**VALUE ENGINEERING STUDY**  
**OF**  
***US 641***

**ITEM NUMBERS: 11-278.24 & 11-278.27**

**Caldwell/Crittenden County, Kentucky**

**April 7-11, 2008**

AS PROPOSED 5' DRAINAGE BLANKET – EMBANKMENT

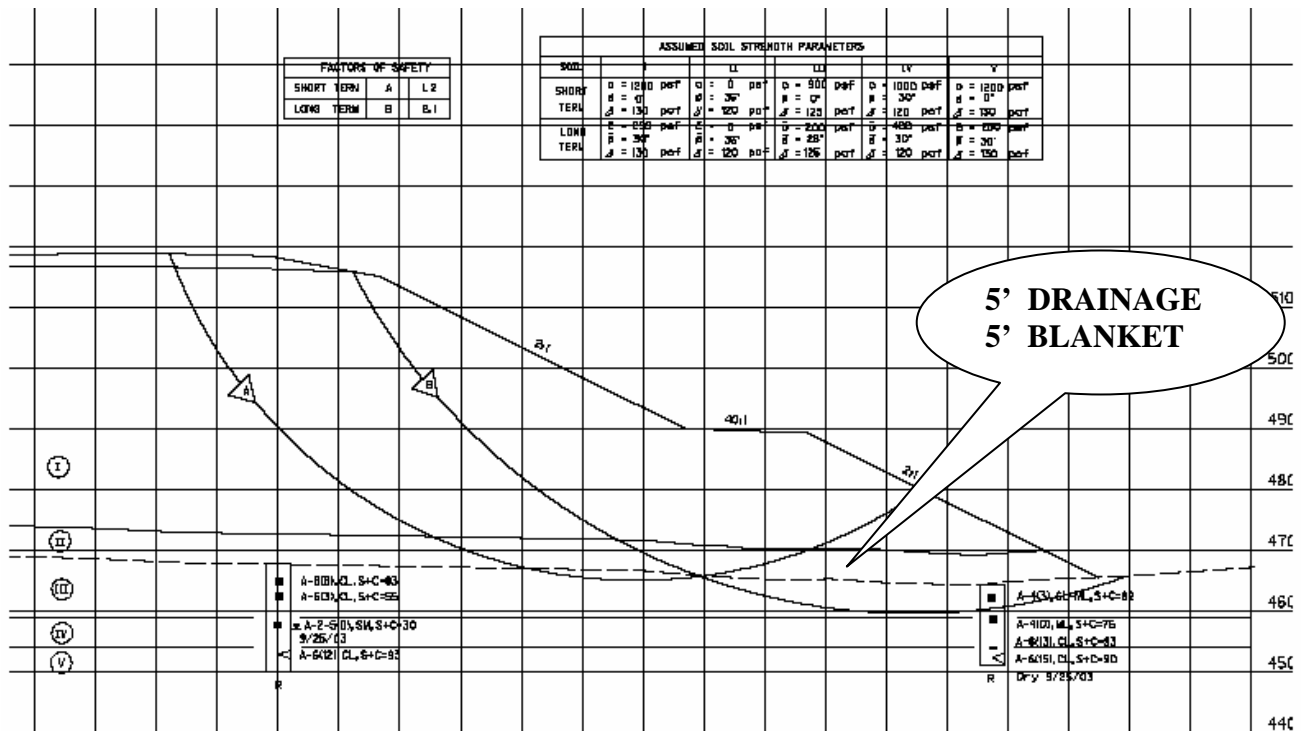
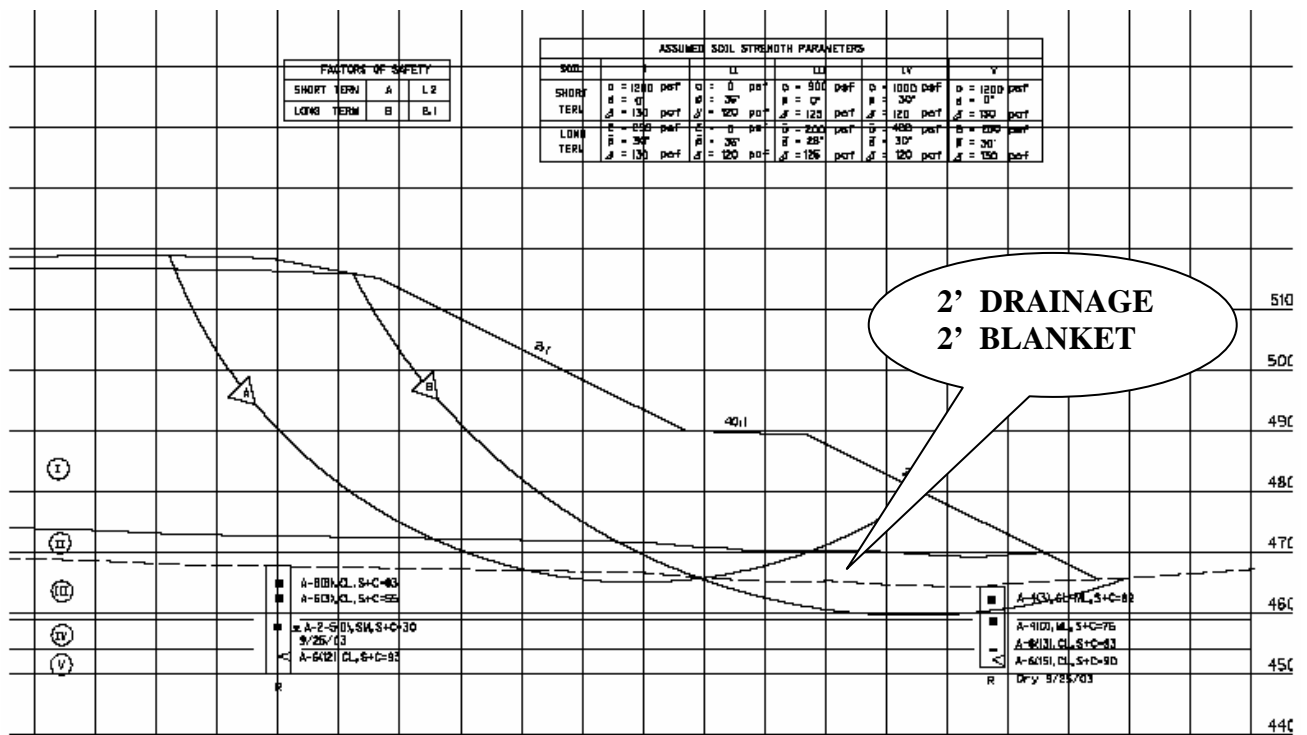
The Value Engineering Team recommends reducing the drainage blanket from 5 feet to 2 feet in order to reduce the amount of quantities on the project. The drainage blanket runs from toe to toe in order to maintain positive drainage. A two-foot drainage blanket will convey all the water from the seepage areas. The proposal will reduce the drainage blanket from 126,562 yd<sup>3</sup> to 50,624 yd<sup>3</sup>. The estimate of \$15.00 per yard would add to a project savings of \$1,139,058.

**VALUE ENGINEERING ALTERNATIVE NUMBER 1  
IMPROVE EXISTING US 641 TYPICAL SECTION**

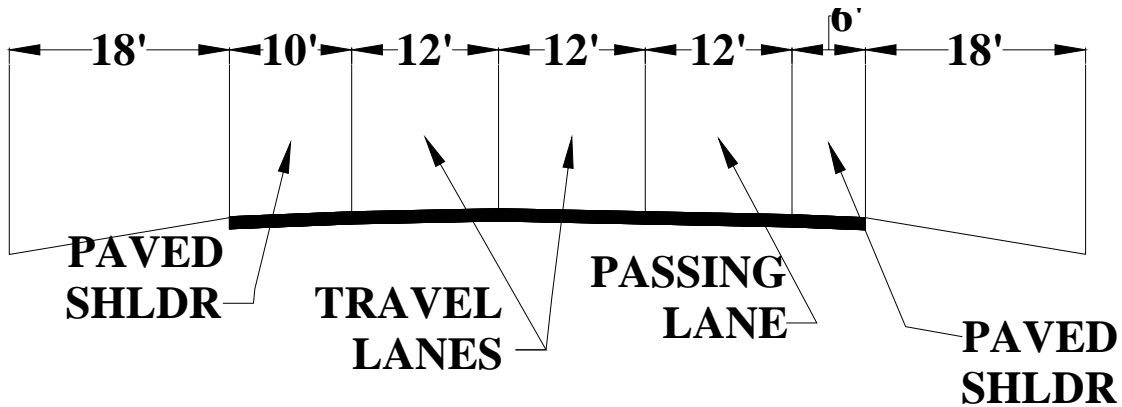
*Utilize existing US-64 Right of Way, add passing lanes along with other minor improvements.*

The Value Engineering Team Recommends making minor improvements where needed and to rehabilitate the existing roadway. The traffic demand does not warrant the construction of a 4 – lane divided roadway.

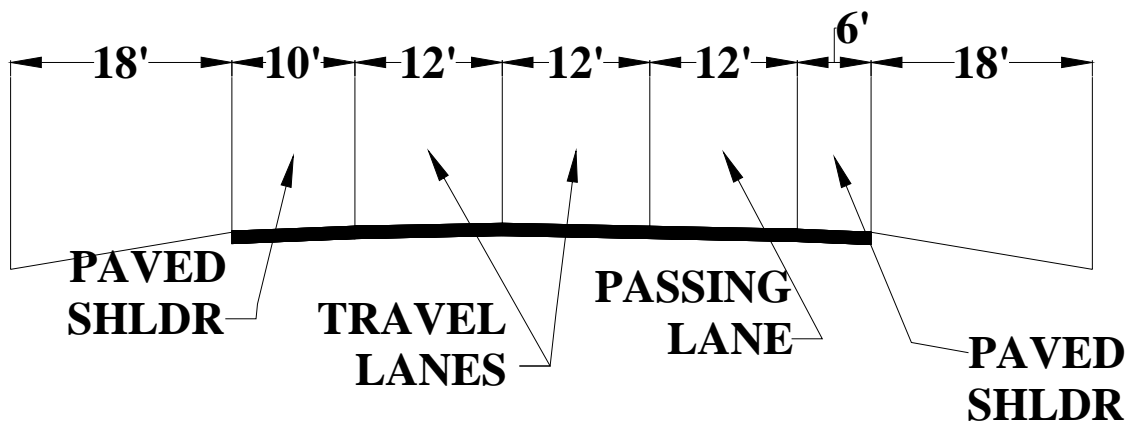
##### Construct 2 – lane roadway within As Proposed Right of Way.

The ADT on existing US 641 is barely 4000 vehicles per day that is well below the operational capacity for a two-lane rural roadway. The VE Team is also very skeptical of the model data that suggests that an additional 10,000 vpd might use the corridor if a 4-lane facility were to be built. Would that mean 15,000 vpd might use the corridor if a 6-lane facility were built? We believe that this data should be evaluated thoroughly before being used as a basis for any design.

The VE Team's opinion is that no reasonable basis for designing the proposed facility with a design speed of 70 mph (interstate standards). The proposed facility should be a partially controlled access facility with several access, egress and crossing points. A 70 mph design speed limits the design team's ability to maximize the practicality of their design, as well as, increasing the risk of severe accidents on the facility.

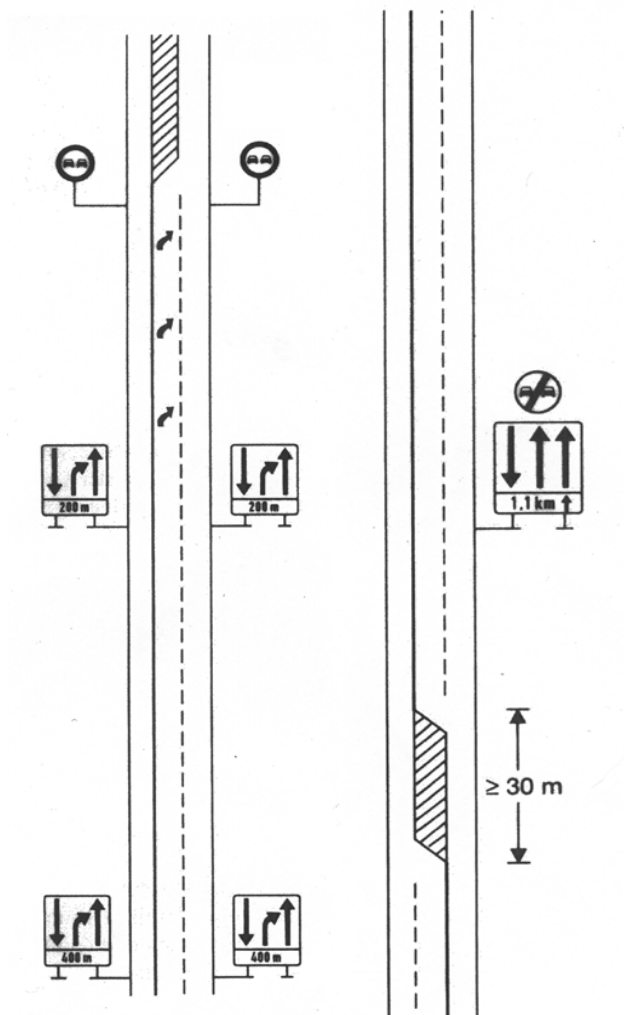
*Construct 3 – lane roadway.*

The Value Engineering Alternative Number 4 under the Pavement category is a 3-lane roadway, also known as a 2+1 roadway. The typical section is composed of 3-12' lanes. The outside shoulders would remain the same as the proposed and the inside shoulders would be eliminated.

The 2+1 roadway is a continuous 3-lane cross section with alternating passing lanes. This alternative operates effectively with volumes of 15,000 to 25,000 ADT. The majority of rural roads in the US have only 2 lanes. Some European countries have been able to modify their 2 lane roads utilizing the 2+1 roadway design and driver response has been positive. They have reported accident rates 22-46% lower than for conventional 2 lane roadways. The lanes can be separated by pavement markings and in some cases cable barriers. The US has safety concerns about barrier deflection and tort liability and would like to evaluate these issues before implementing cable barriers with a 2+1 design on US roadways.

AS PROPOSED BRIDGE ELEVATION

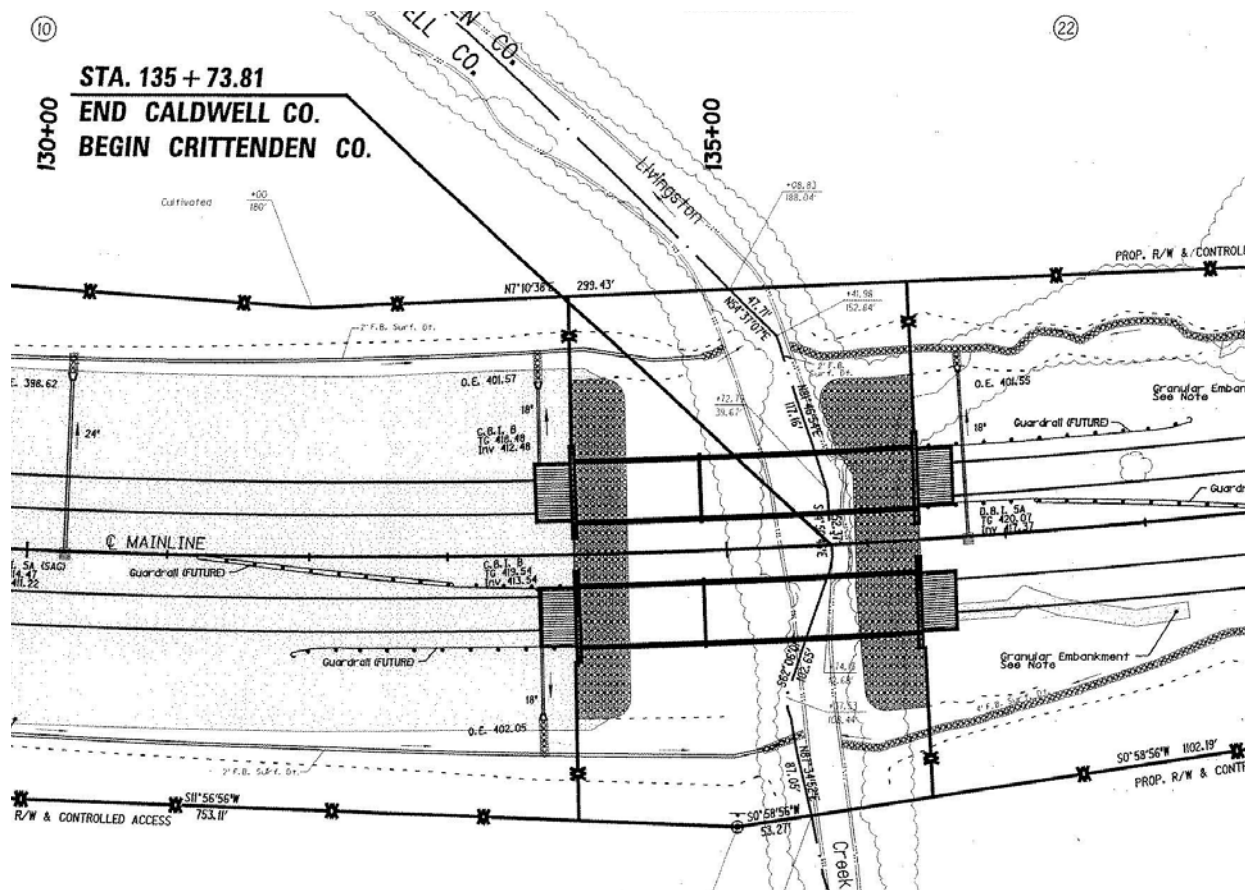
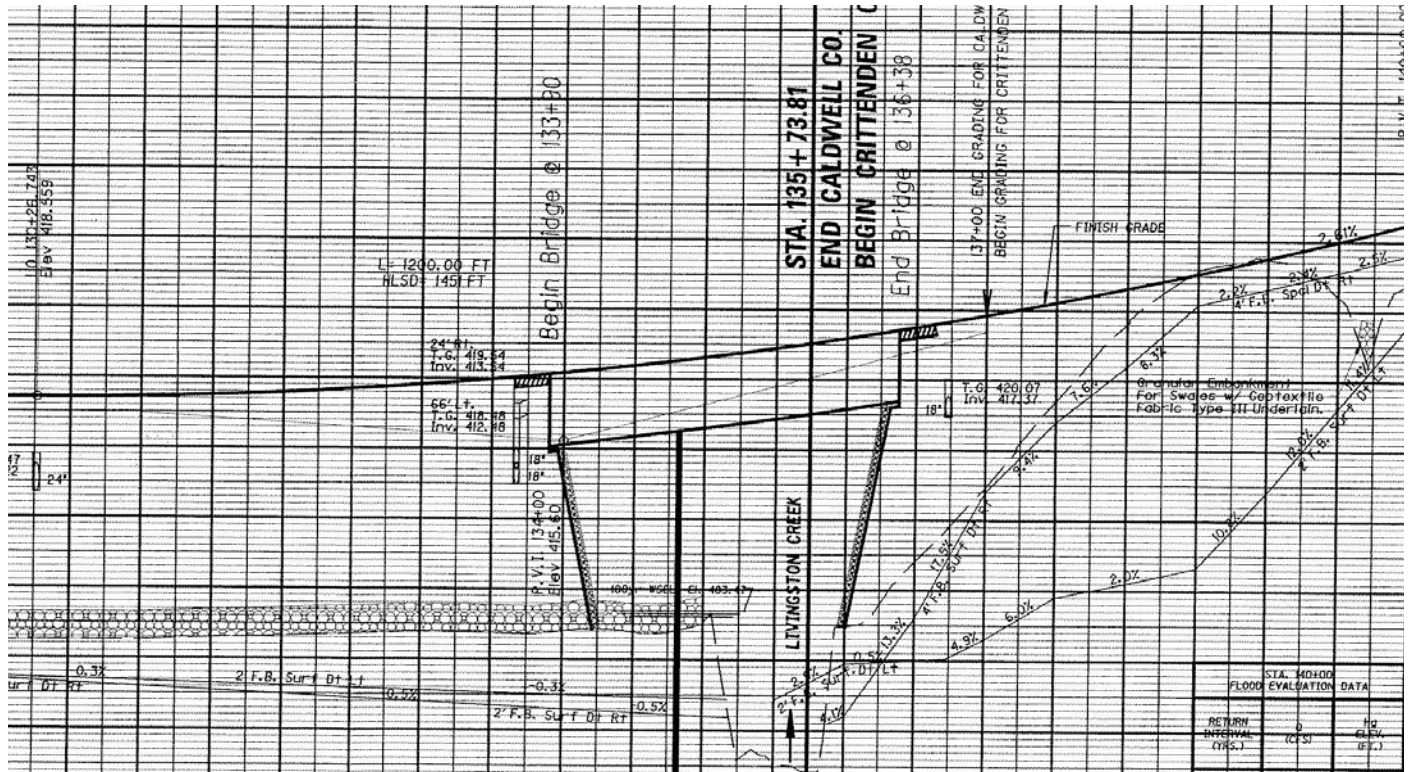
**“As Proposed”:** Construct twin 41’ wide X 248’ long 2 – span (94’, 154’) bridges over Livingston creek.

- High construction cost.
- Generous low member clearance.

**BRIDGE - SHORTEN BRIDGE  
VALUE ENGINEERING ALTERNATIVE NUMBER 1  
COST COMPARISON SHEET**

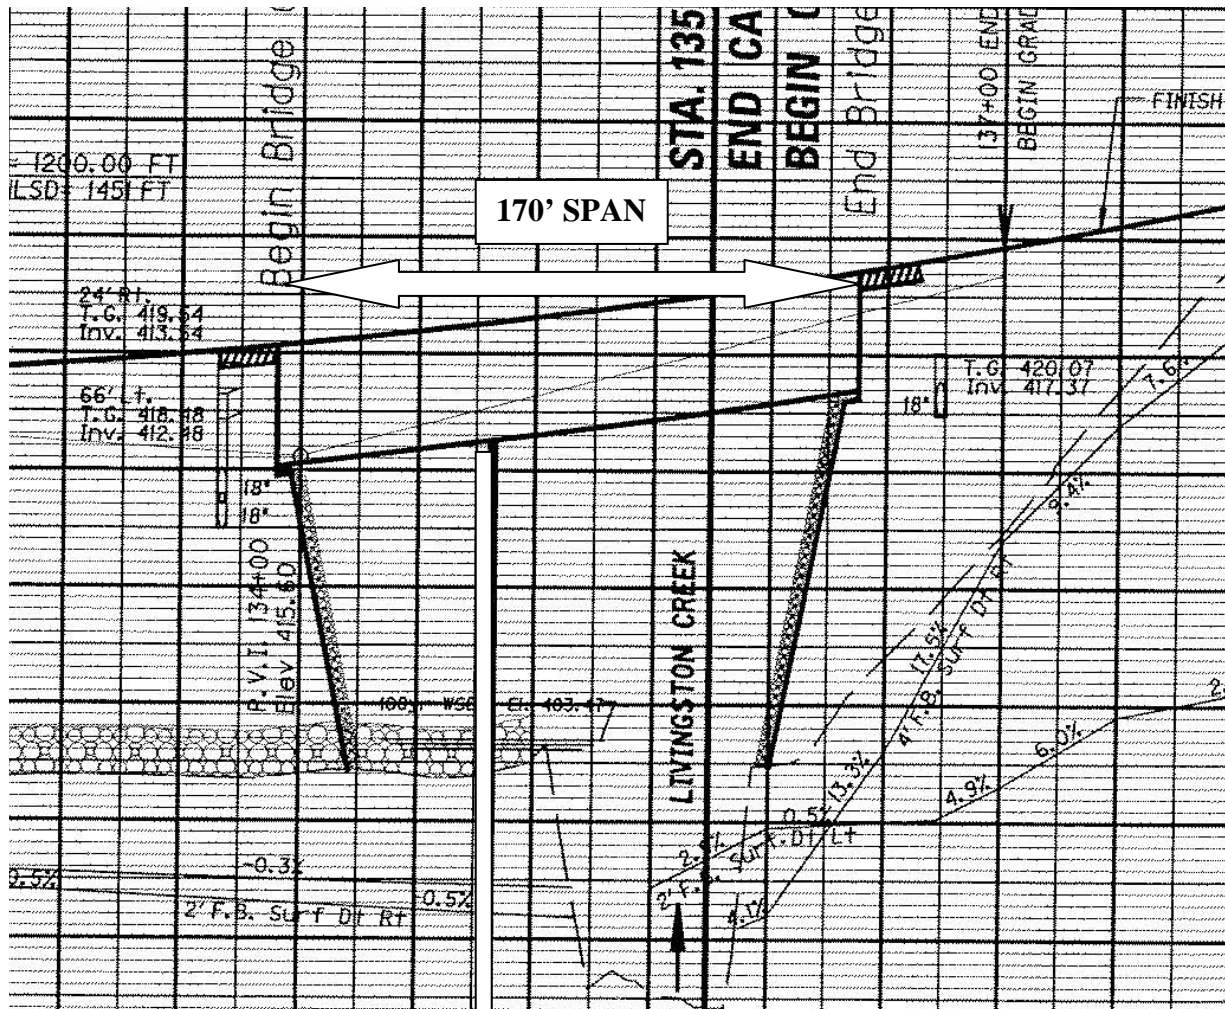
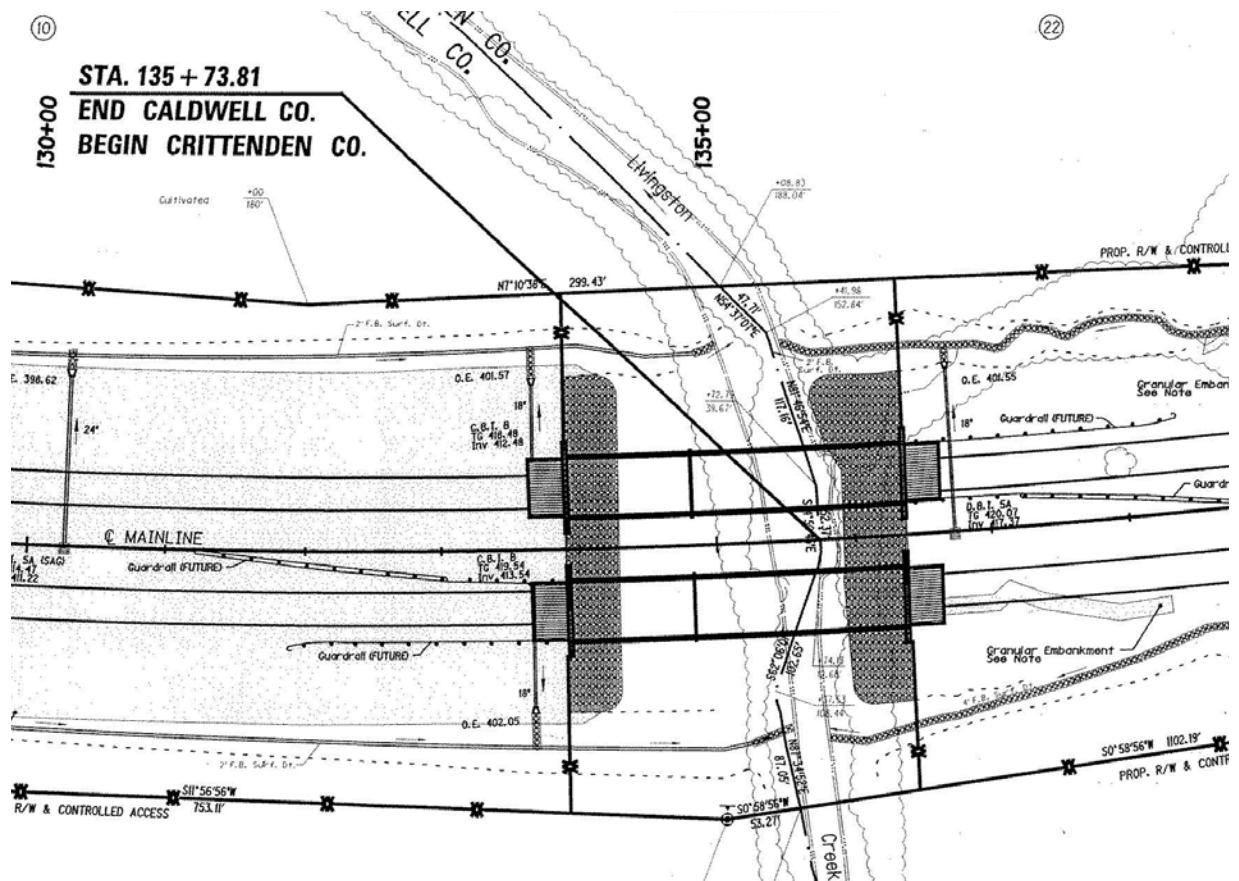
*Value Engineering Alternative Number 1: Construct single span steel plate girder to shorten bridge.*

- May be lower cost.
- Possibly less construction time.
- Eliminates pier from flood plain.

- Increases approach work – pavement/embankment.
